ADDENDUM # 2

Solicitation Name: New Alcona Elementary School – Submission A

ADDENDUM No. 2

STRUCTURAL ADDENDUM #1

DIAGRAMMATIC SECTION THROUGH THE BUILDING SHOWING PROPOSED ENGINEERED FILL N.T.S.
(REFER TO ENGINEERED FILL NOTES ON THIS DRAWING)

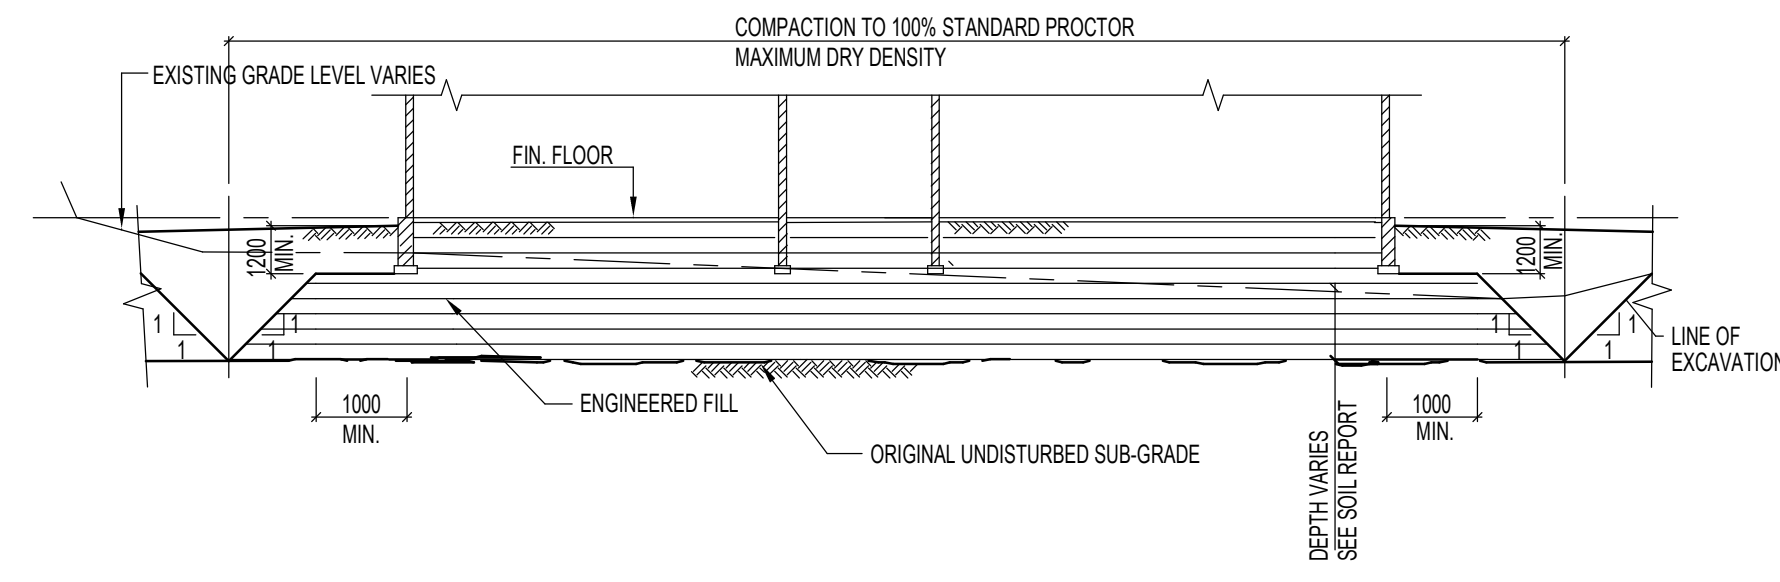
1.0 REFERENCE STRUCTURAL DRAWING S0-01 (RE-ISSUED)

- .1 Updated Engineered Fill Note 3.5/3.5a regarding layer below slab-on-grade. 200mm of 19mm clear stone is required, and the Granular 'A' alternative is now removed. See clouded area.

Project number: 20231581 | S1-01

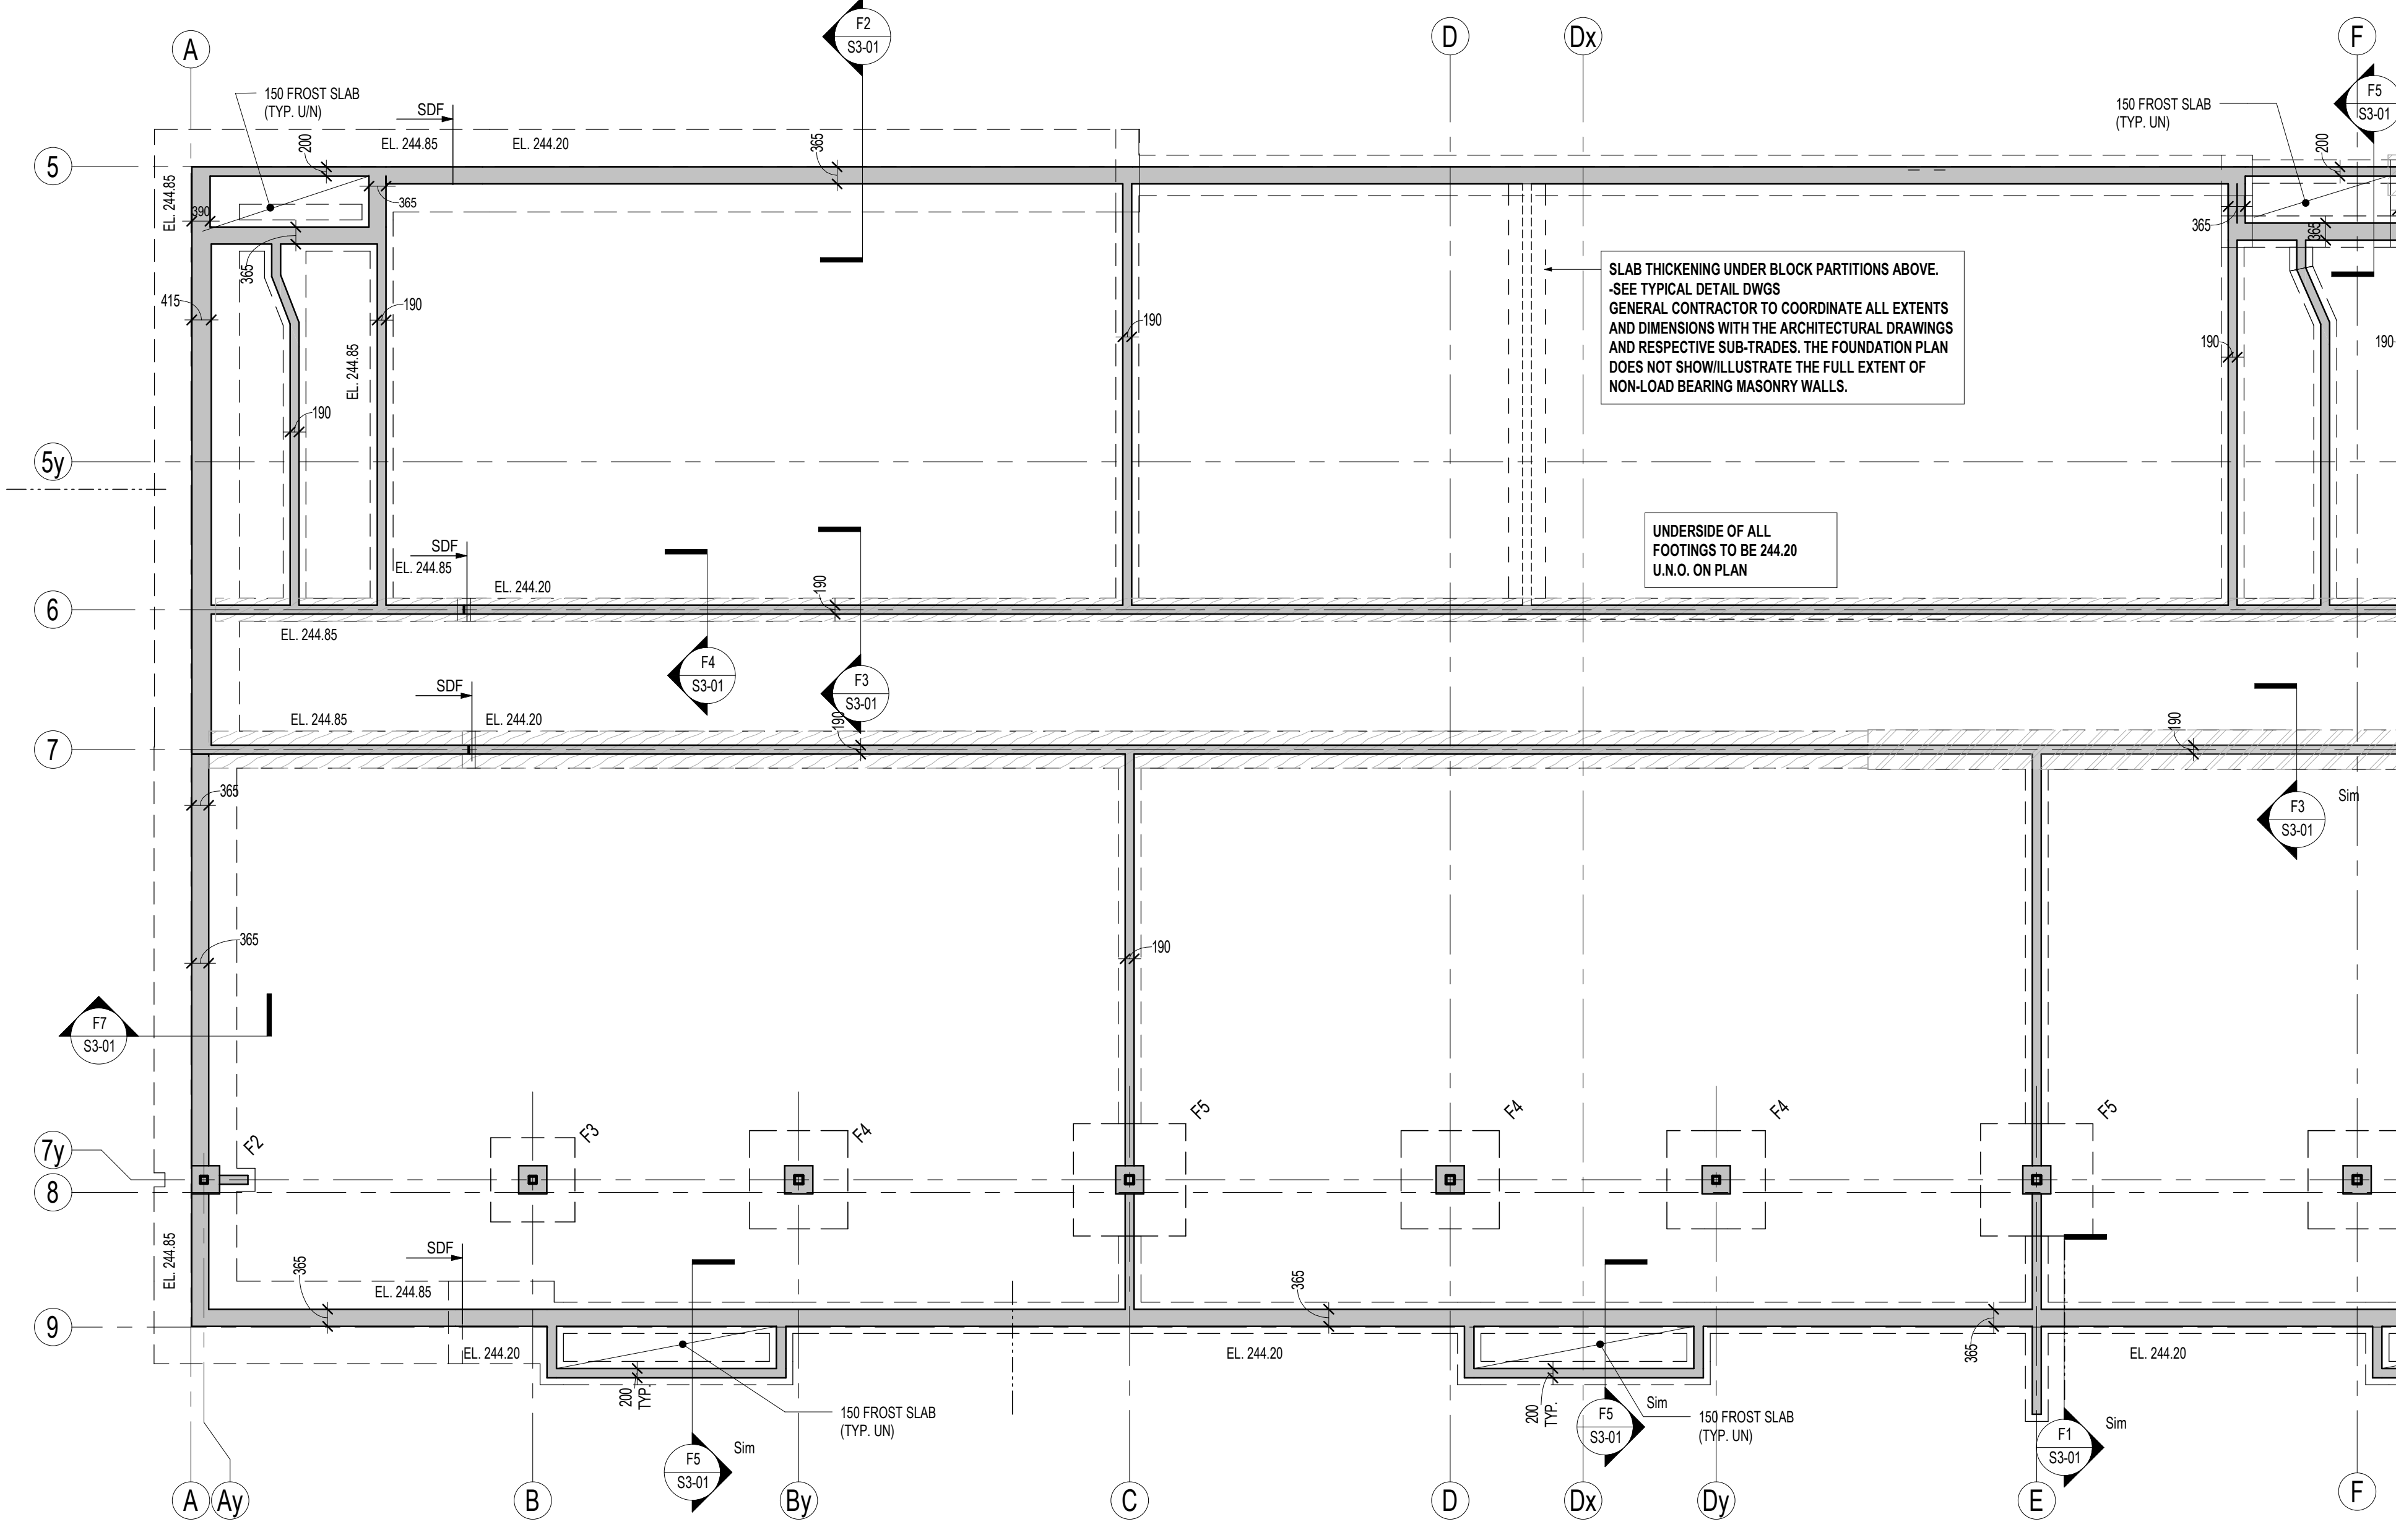
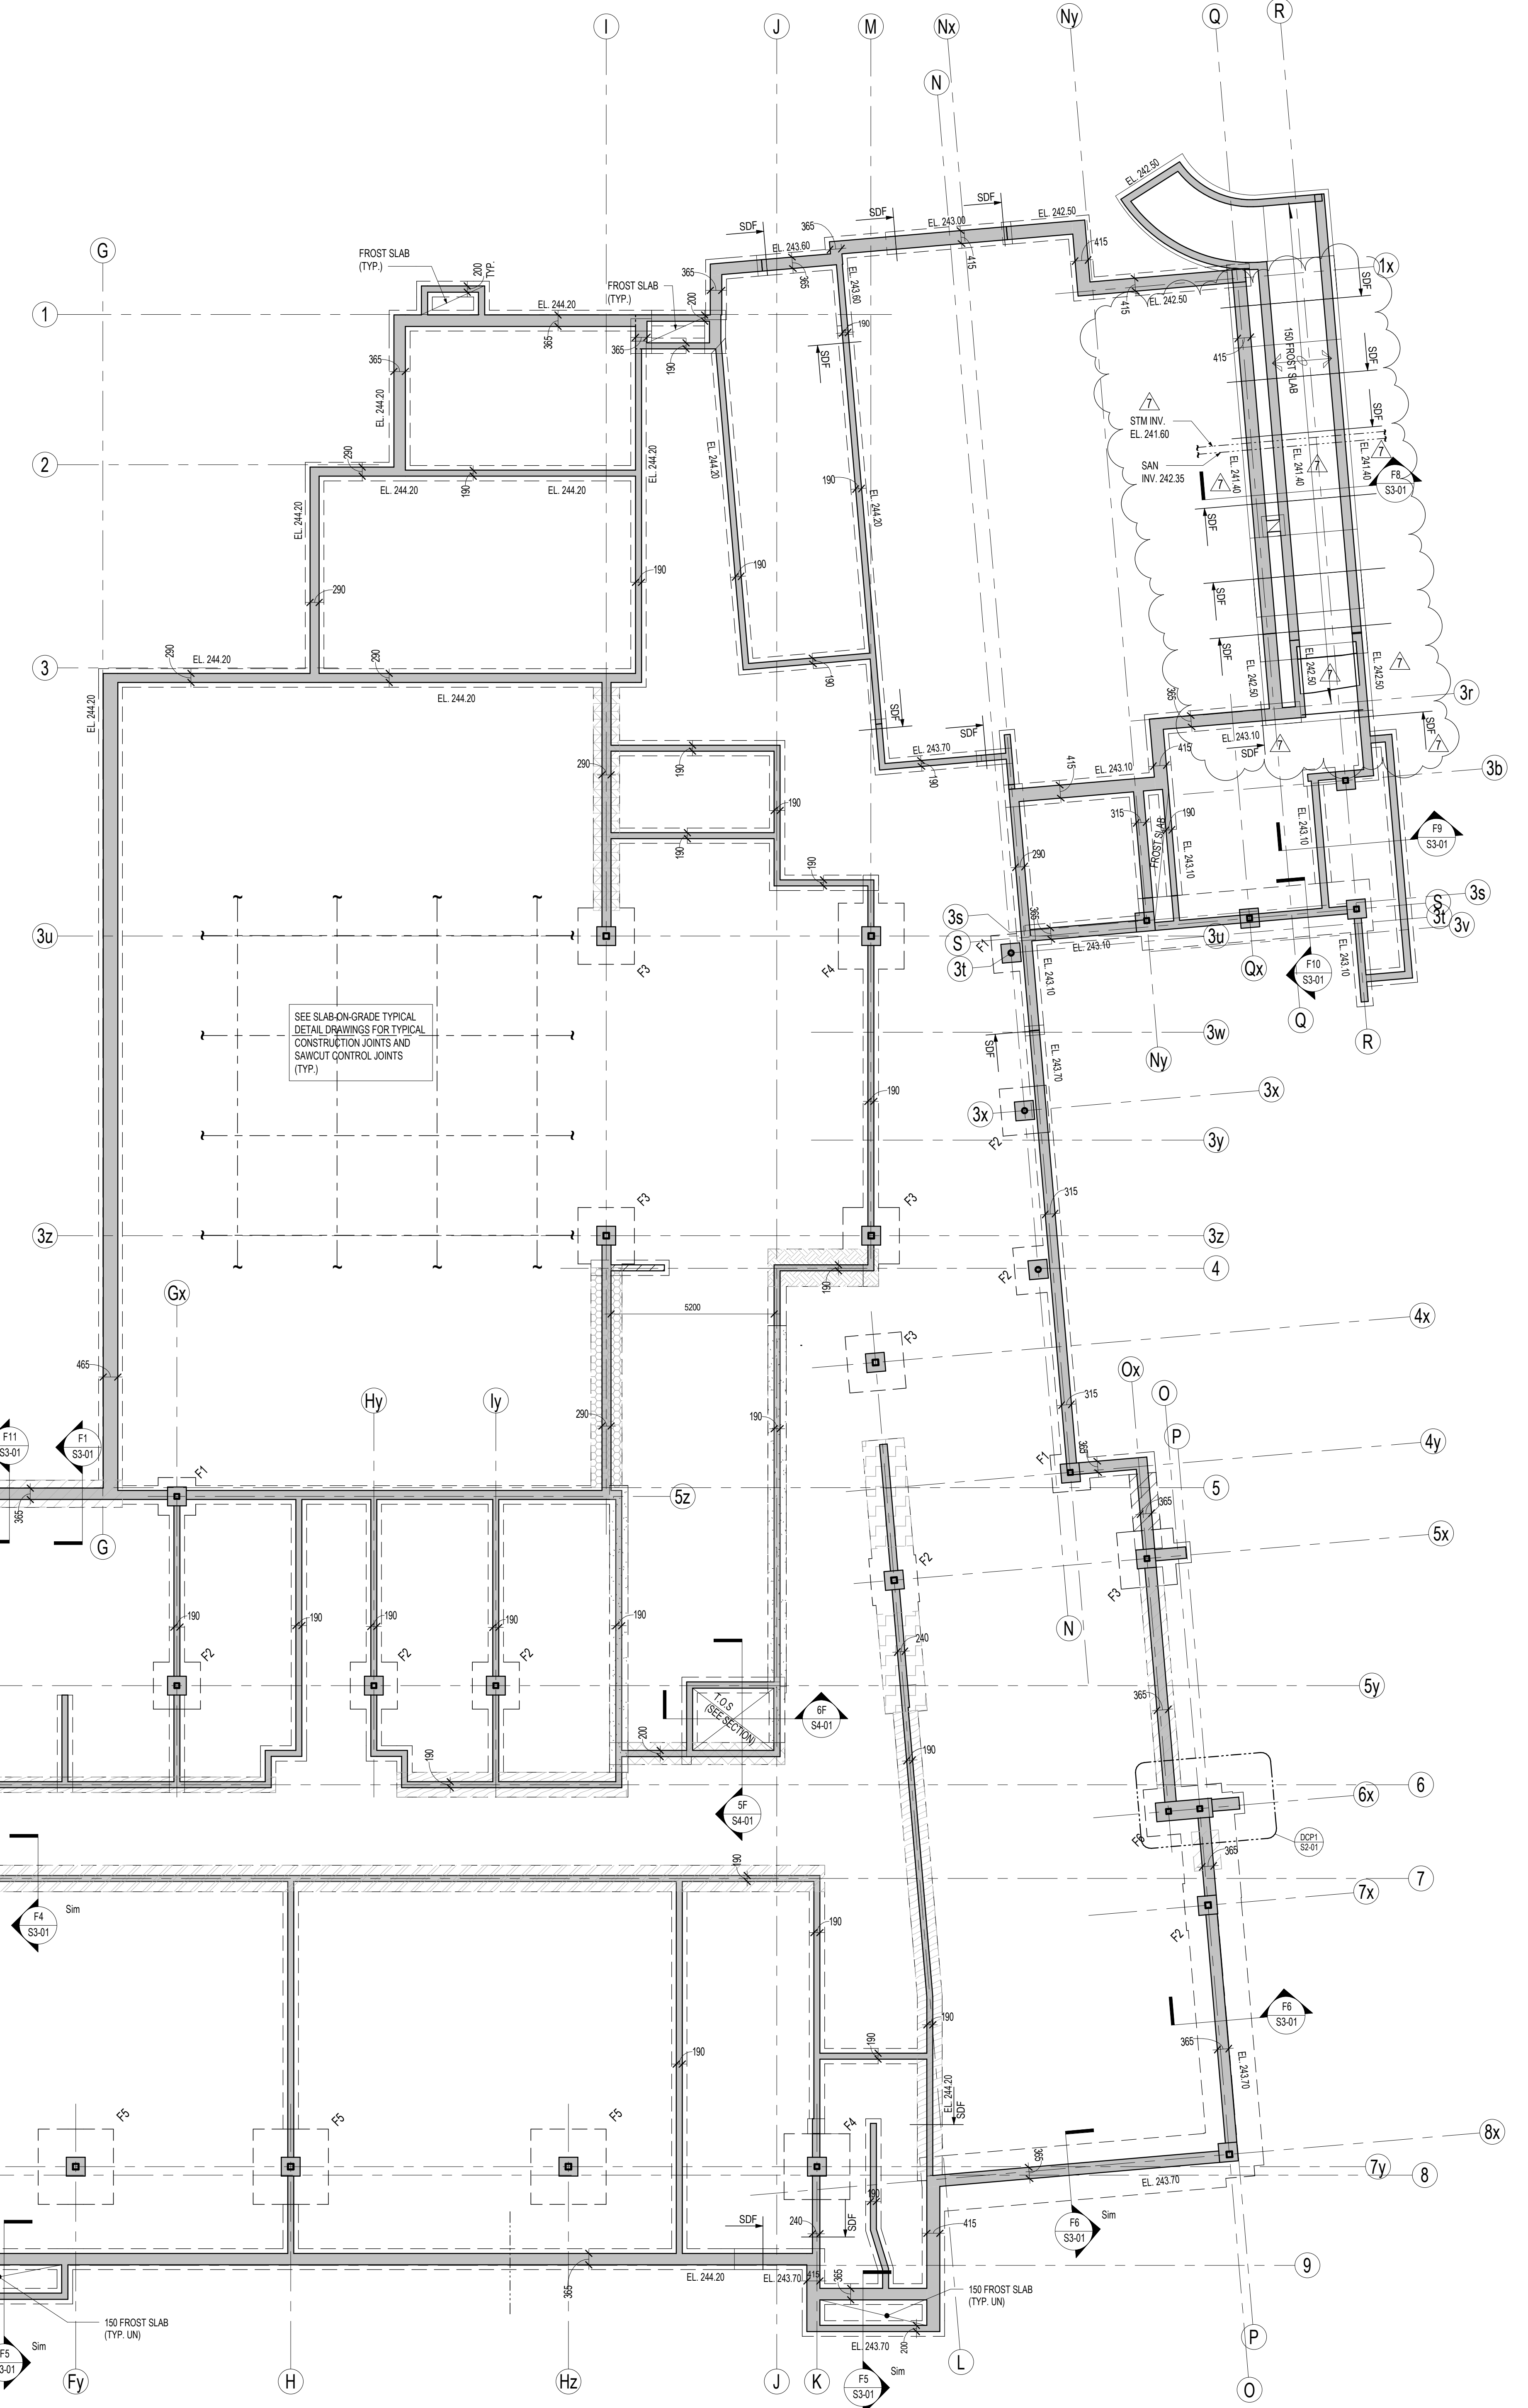
2.0 REFERENCE STRUCTURAL DRAWING S1-01 (RE-ISSUED)

- .1 Added storm line invert elevation. Adjusted lower footing elevation to allow line to pass through foundation wall. See clouded area.
- .2 Clarified underside of footing elevations at SDFs around grids Q and R. See clouded area.
